Re: Cherokee Nation WW Hastings Replacement Hospital - Addendum 02 Narrative

Following is a list of revisions included in Addendum 02.

PROJECT PHASE:
BID PACKAGE 02
(SITE DEMOLITION AND UTILITIES)

STORM DRAIN CONSTRUCTION NOTES

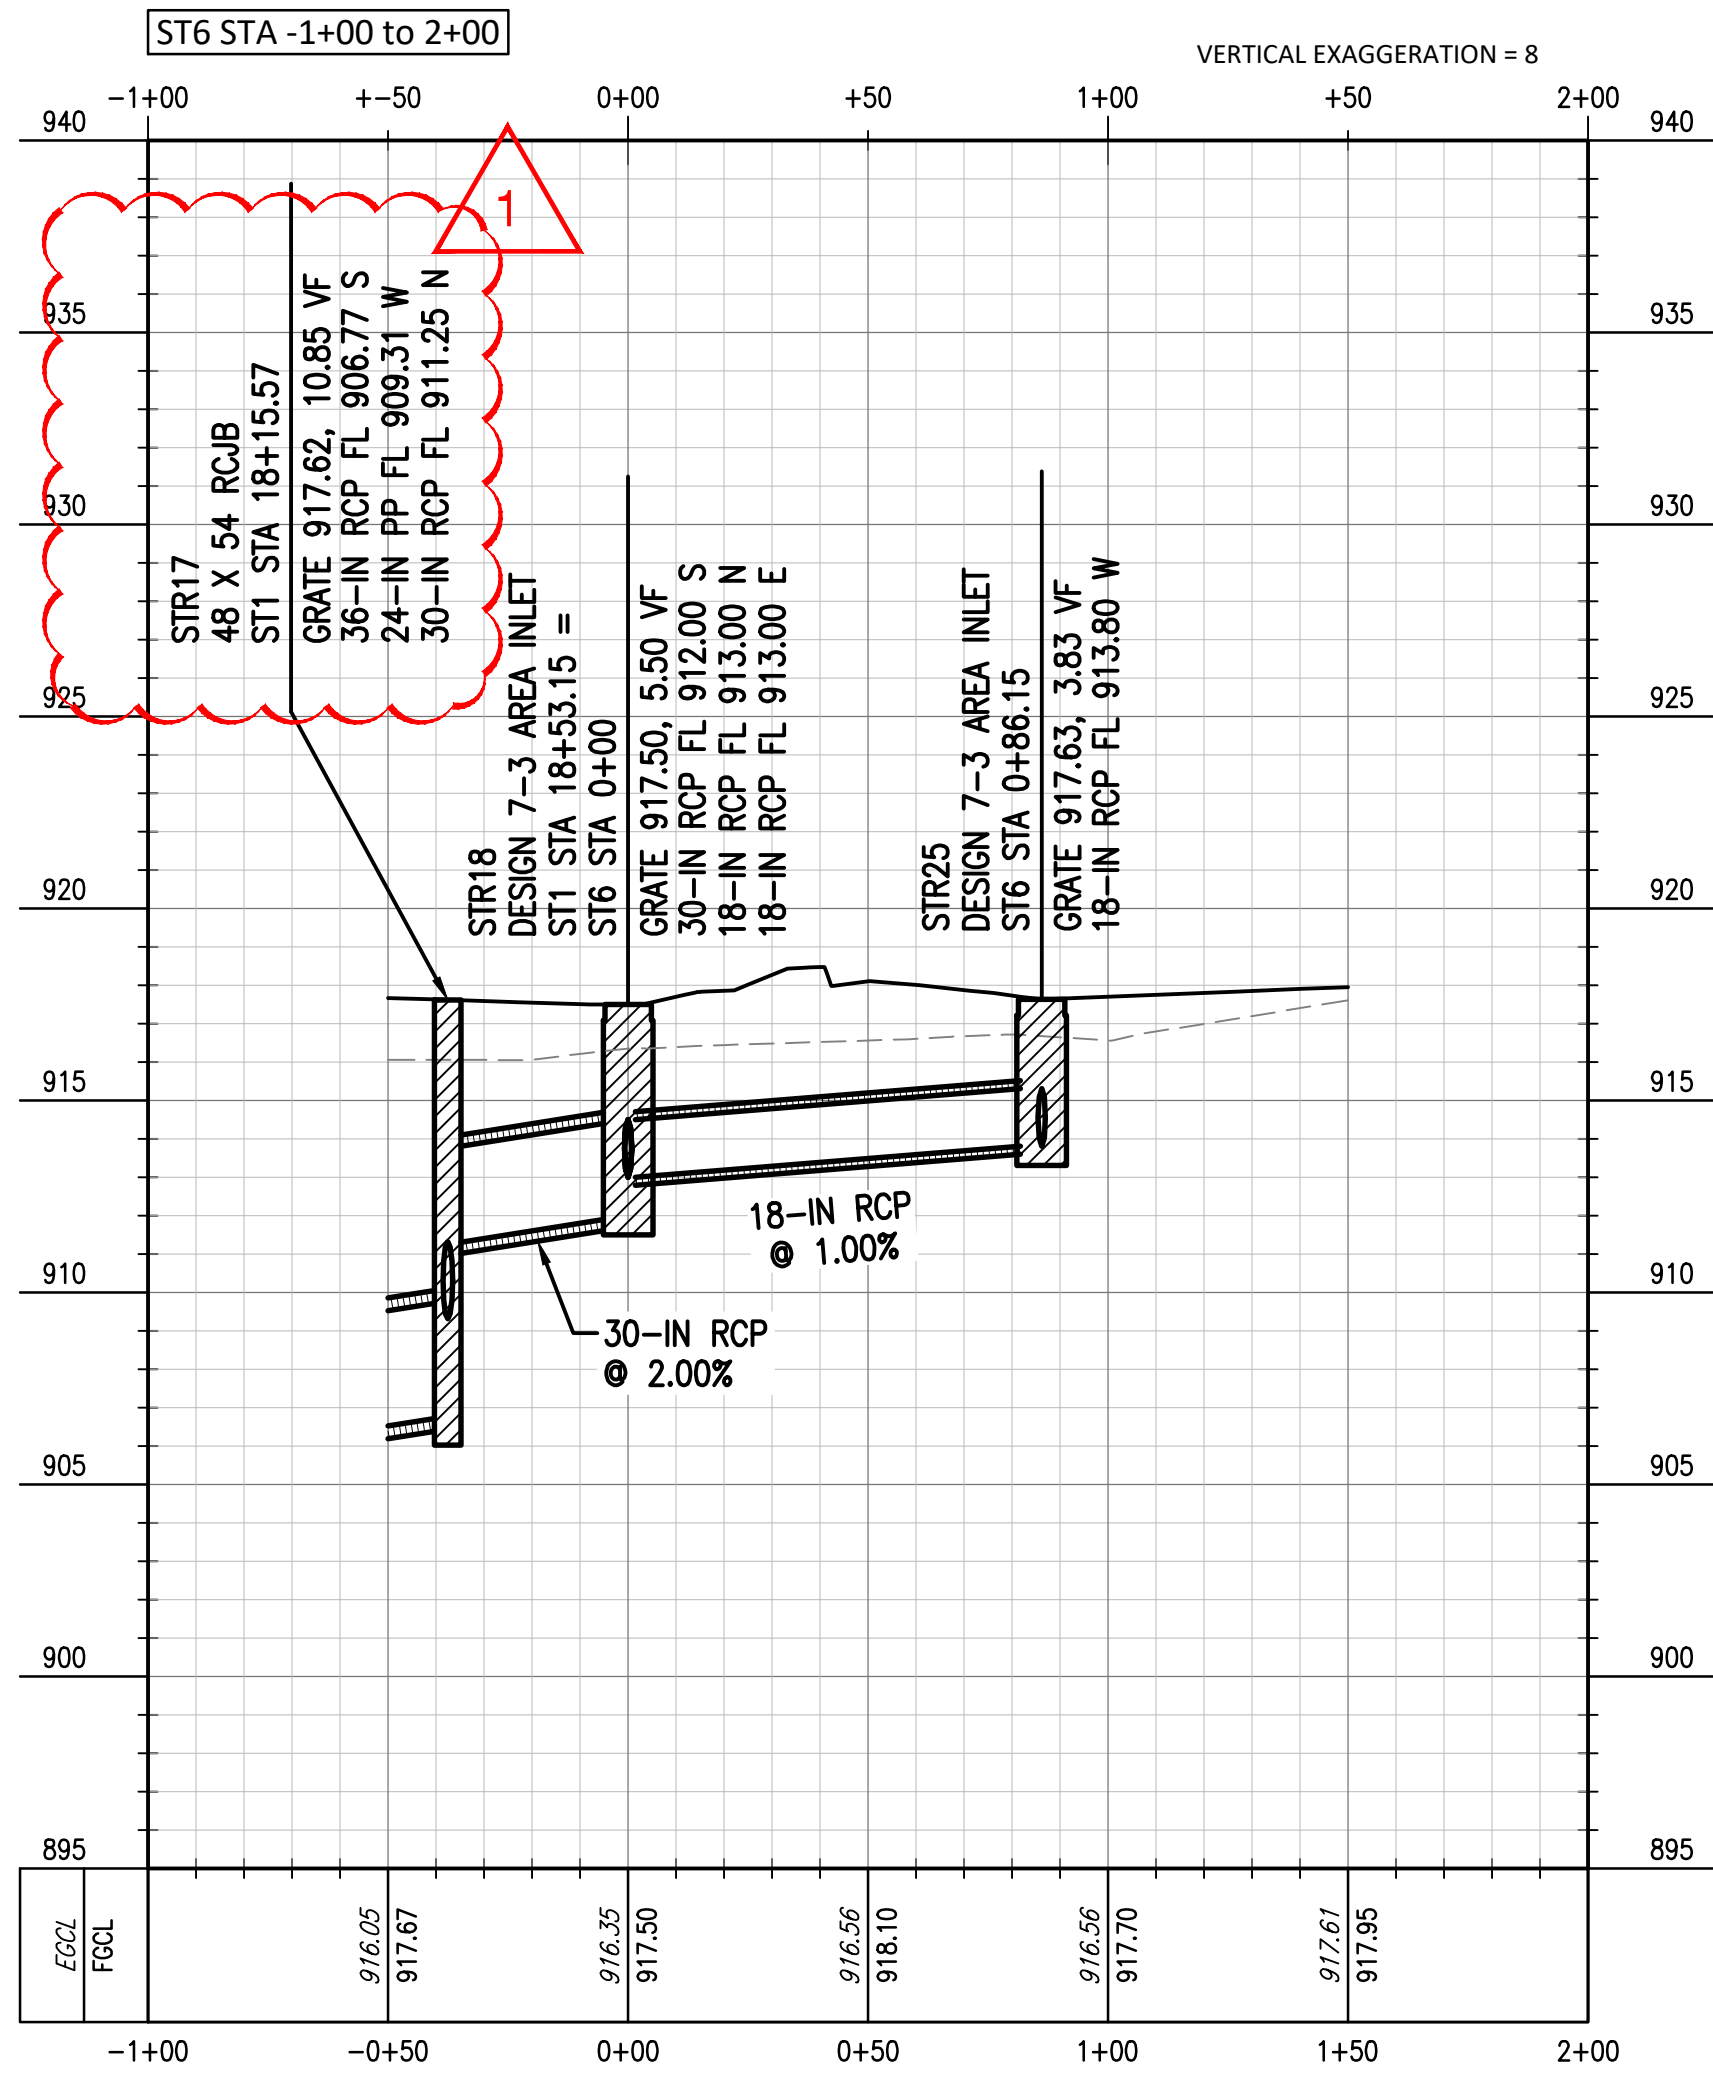
- C6-204 - Added label to STR17 in ST6 profile.
Added label to 45 deg bend in ST8 profile.
Added profile for ST2 to provide a profile of the existing storm sewer to remove from under the Central Energy Plant.
The storm sewer in ST7 profile was lowered so that drainpipes on the upstream end can pass under the 16-in water line.
Added STR38 to ST7 profile.
The pipe from STR33 to STR30 was lowered to pass under the 16-in water line.

SHEET NUMBER:
C7-207

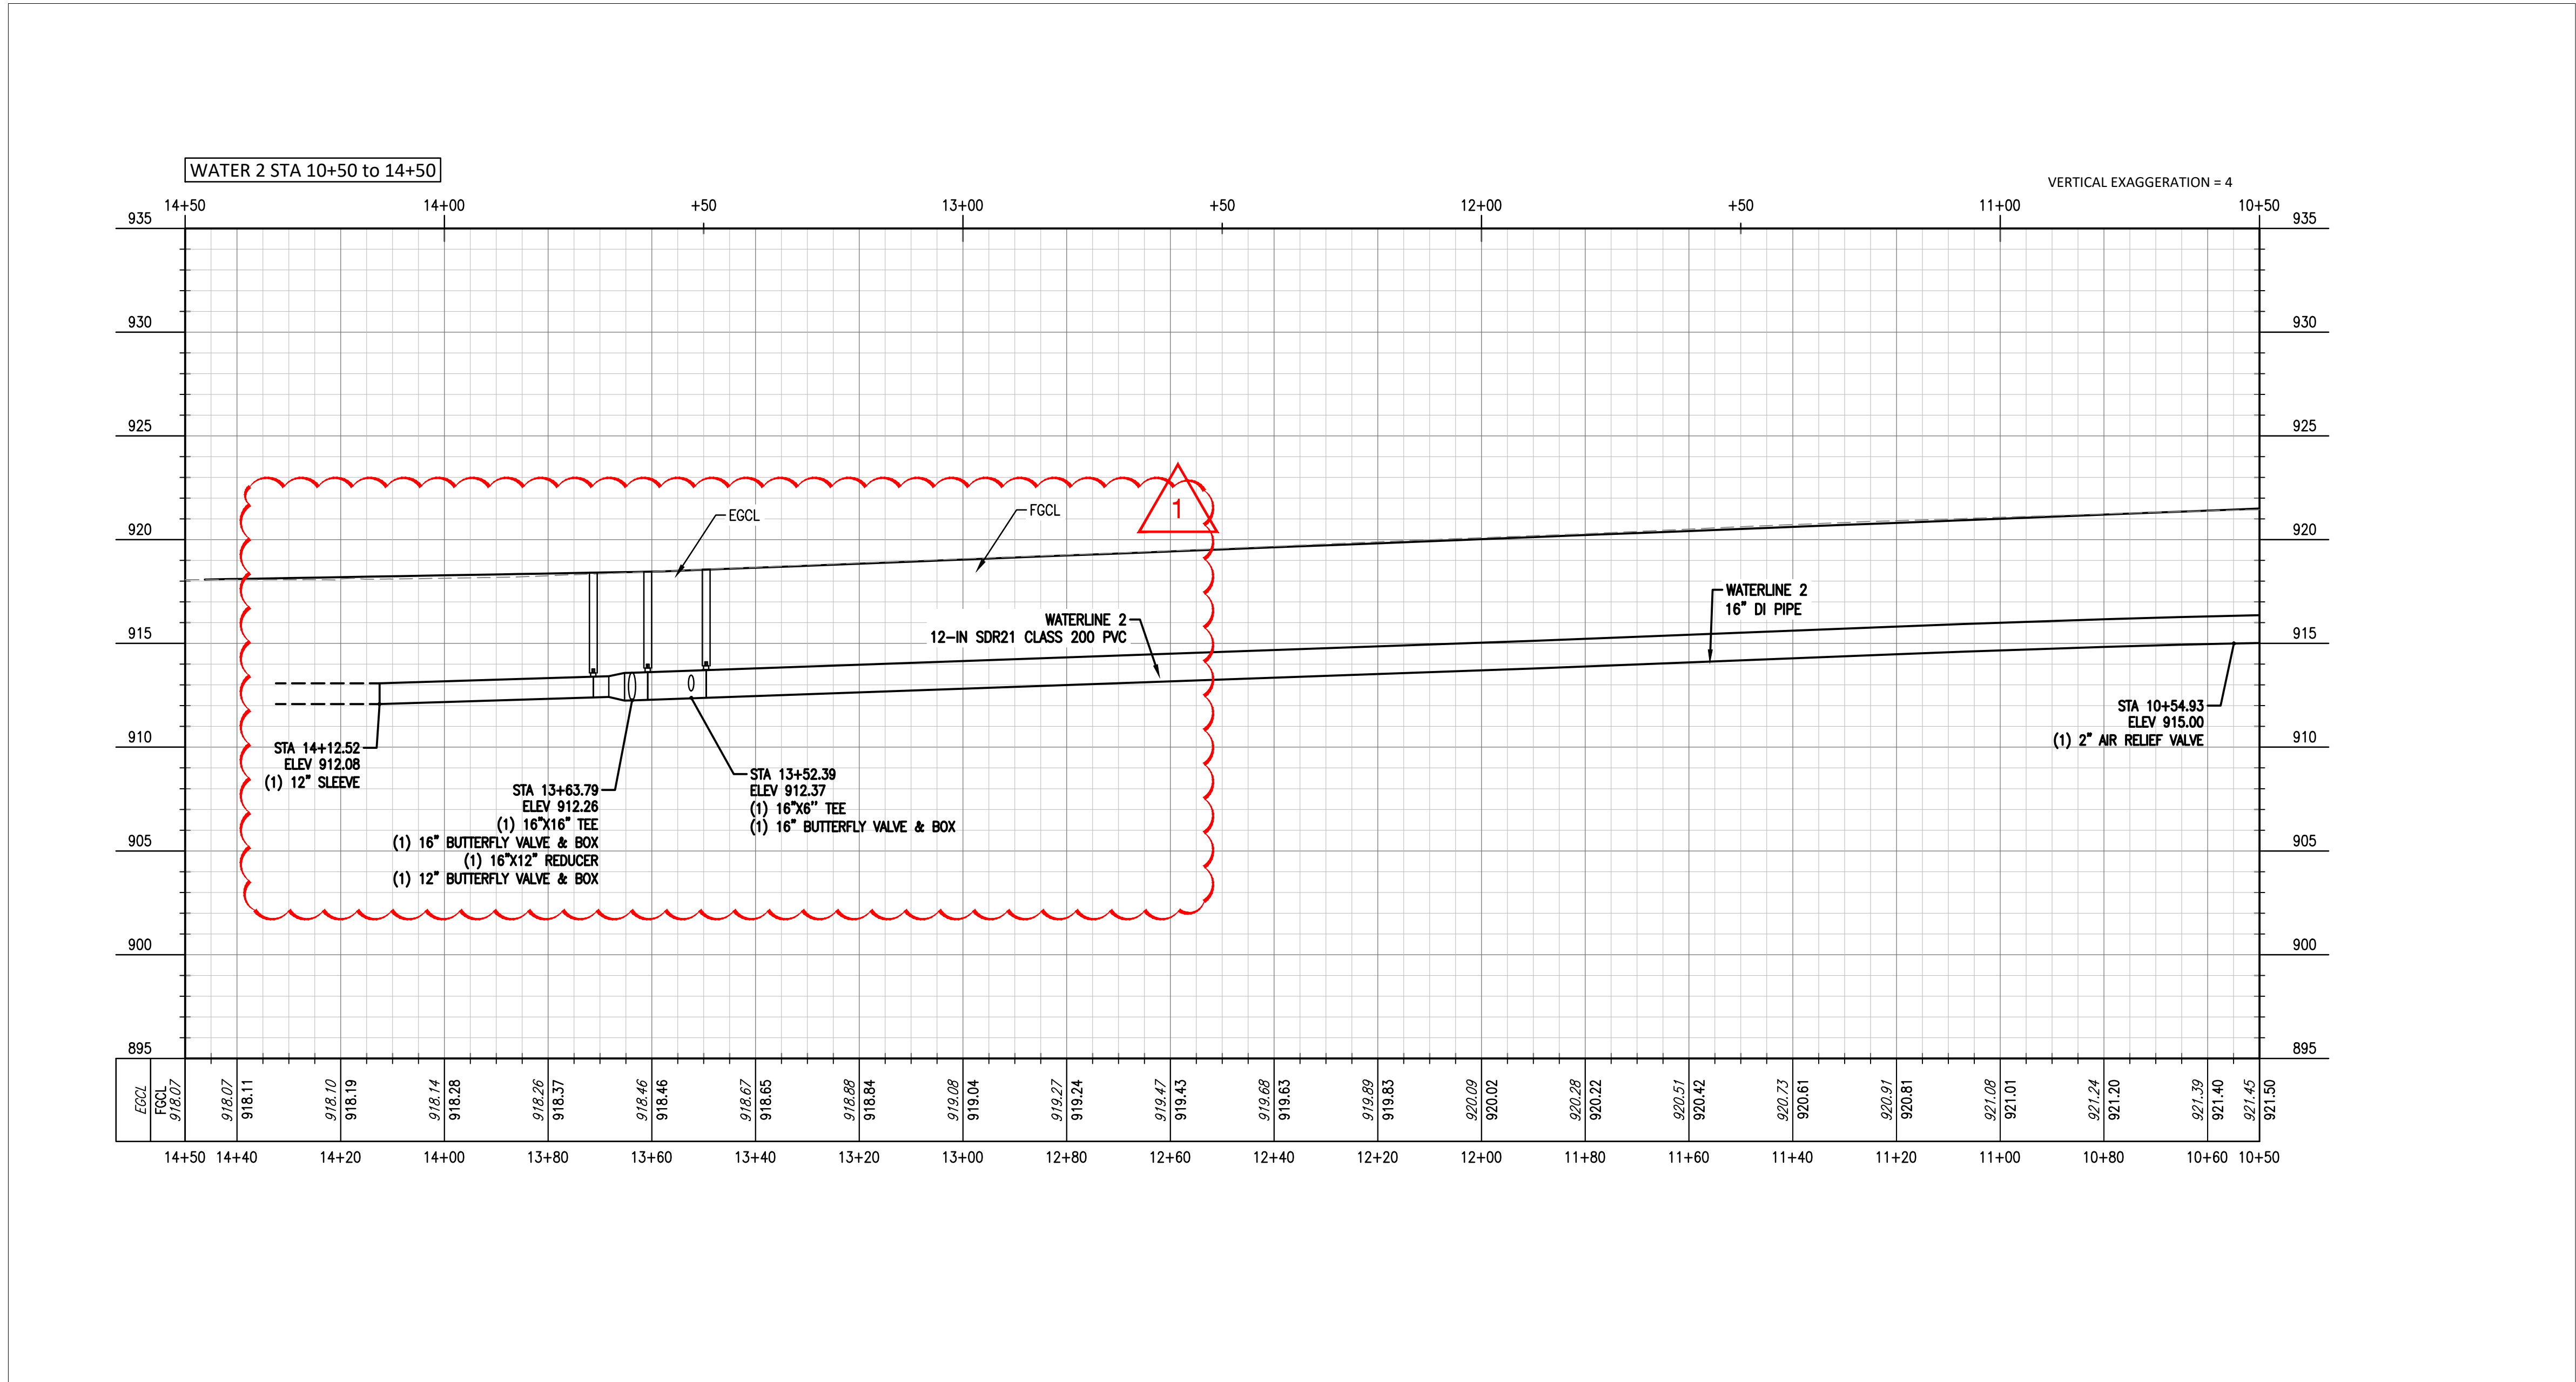
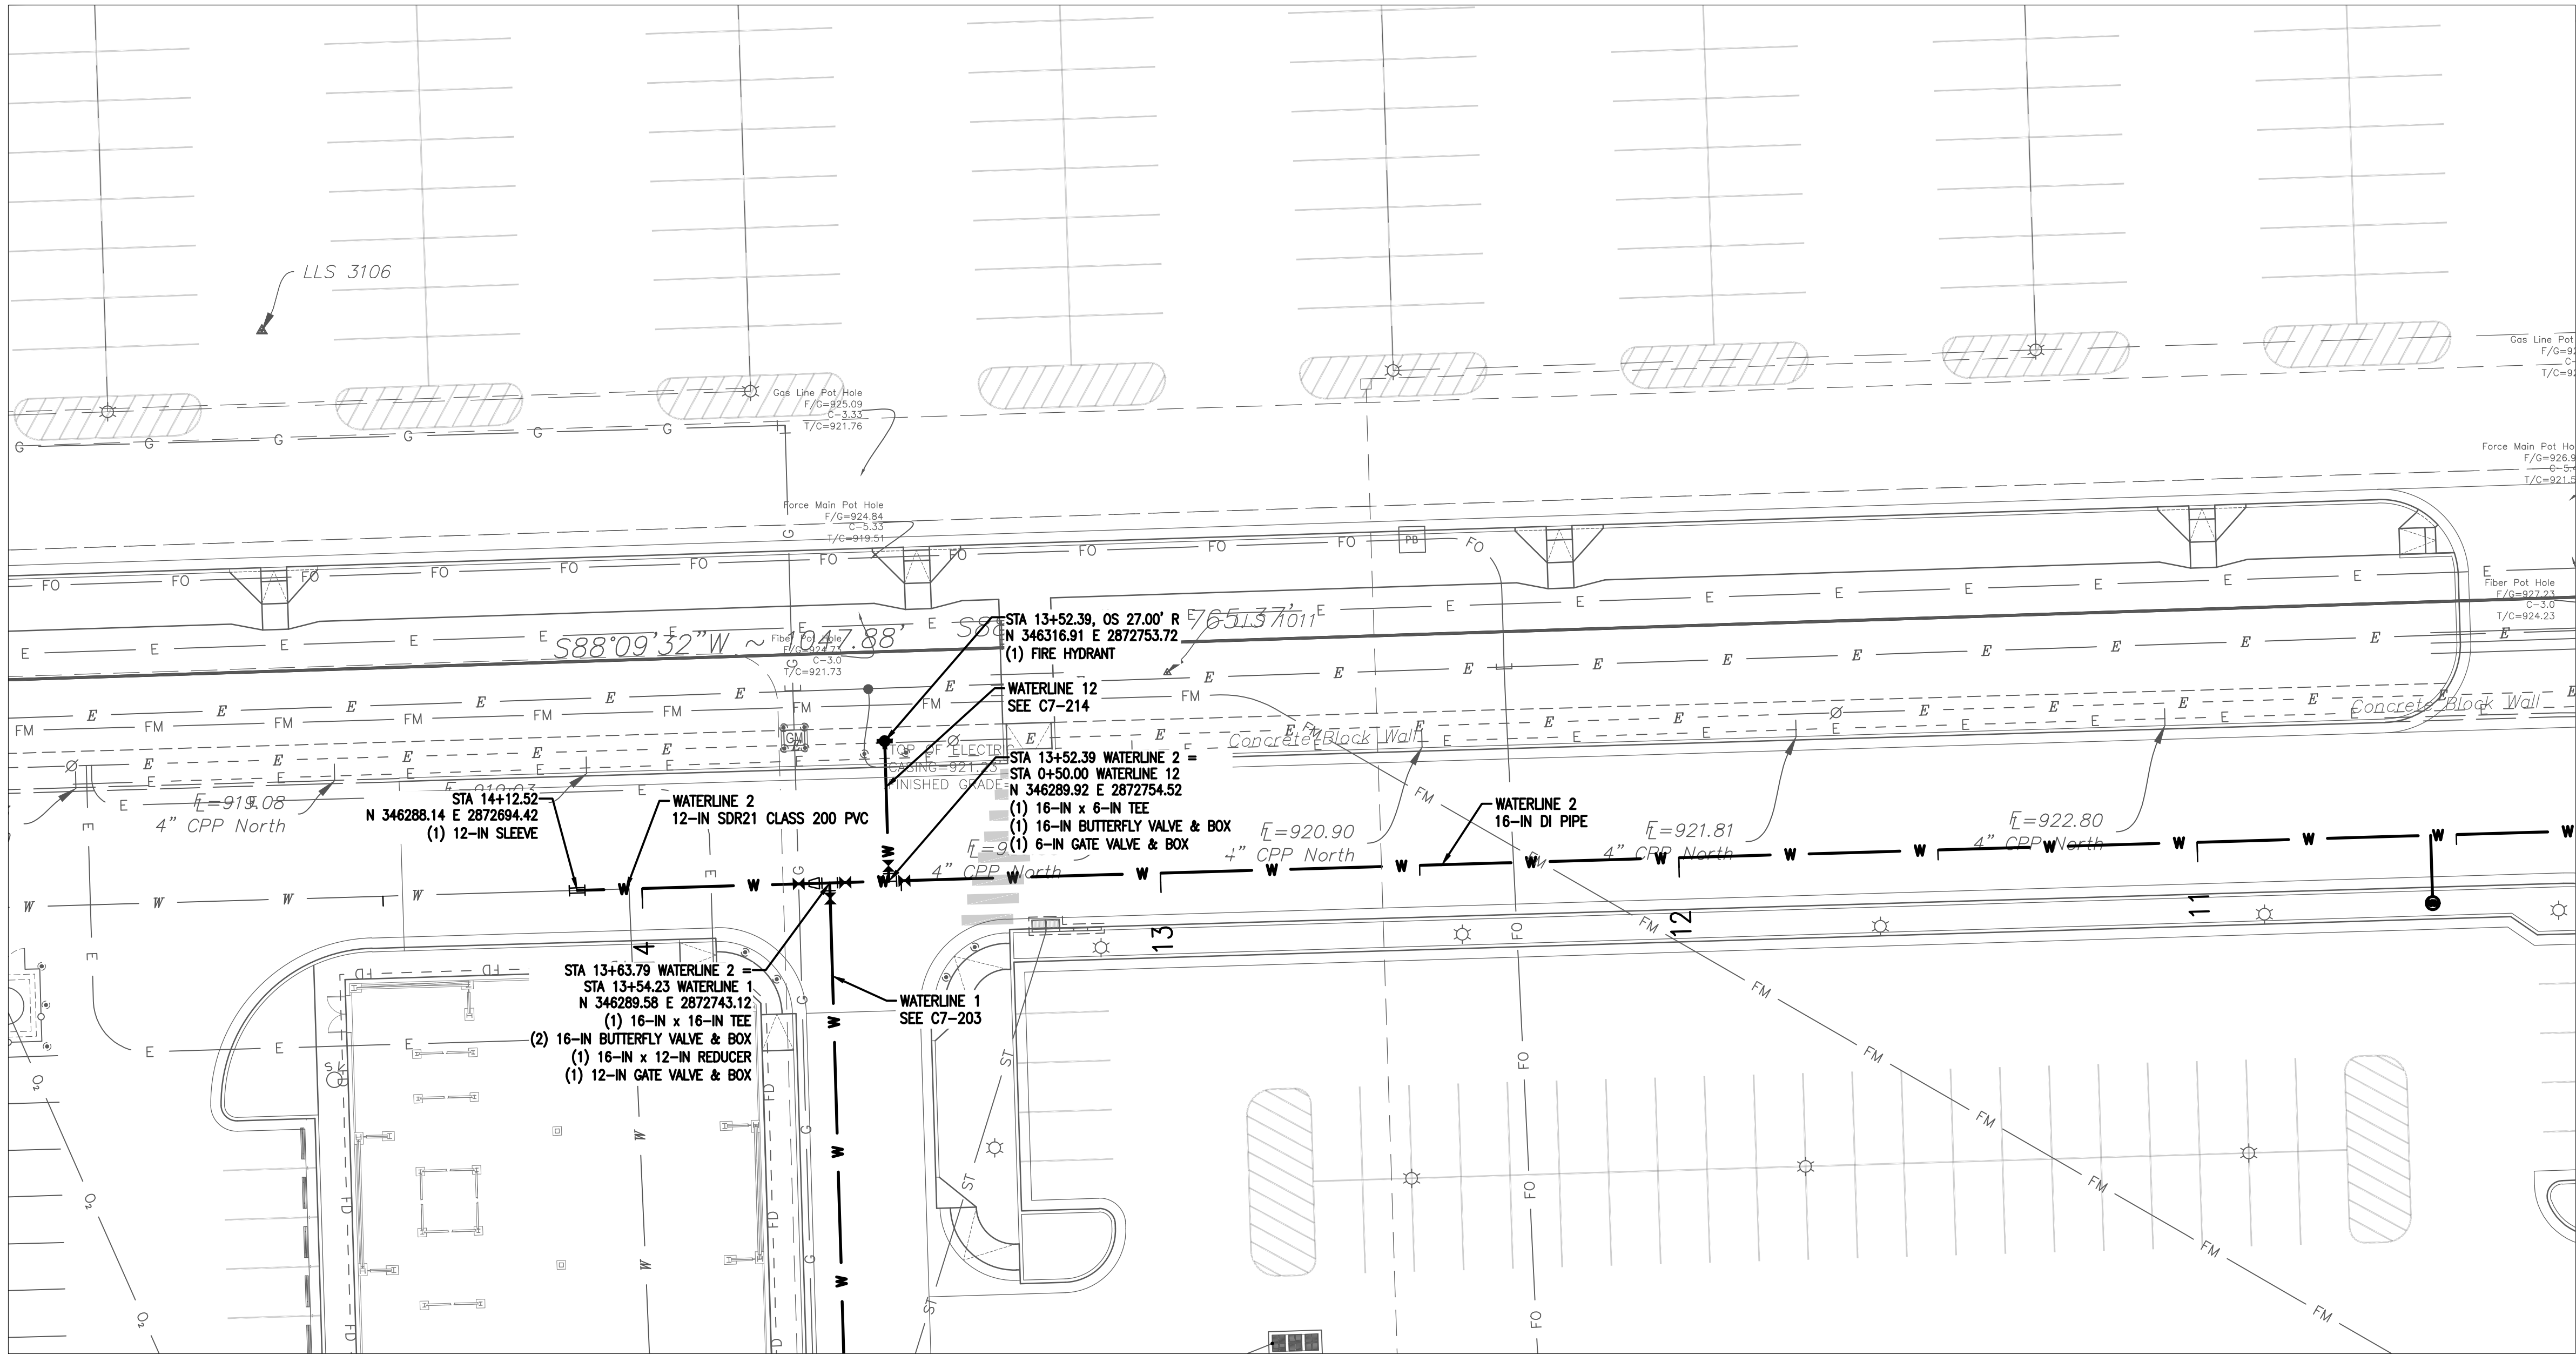
- C7-206 - Added storm sewer crossing pipes to the profile.
- C7-207 - Revised the presentation of the water line in the profile.
- C7-210 - Added label to the plan view.
Revised profile on the east end to match the plan view.
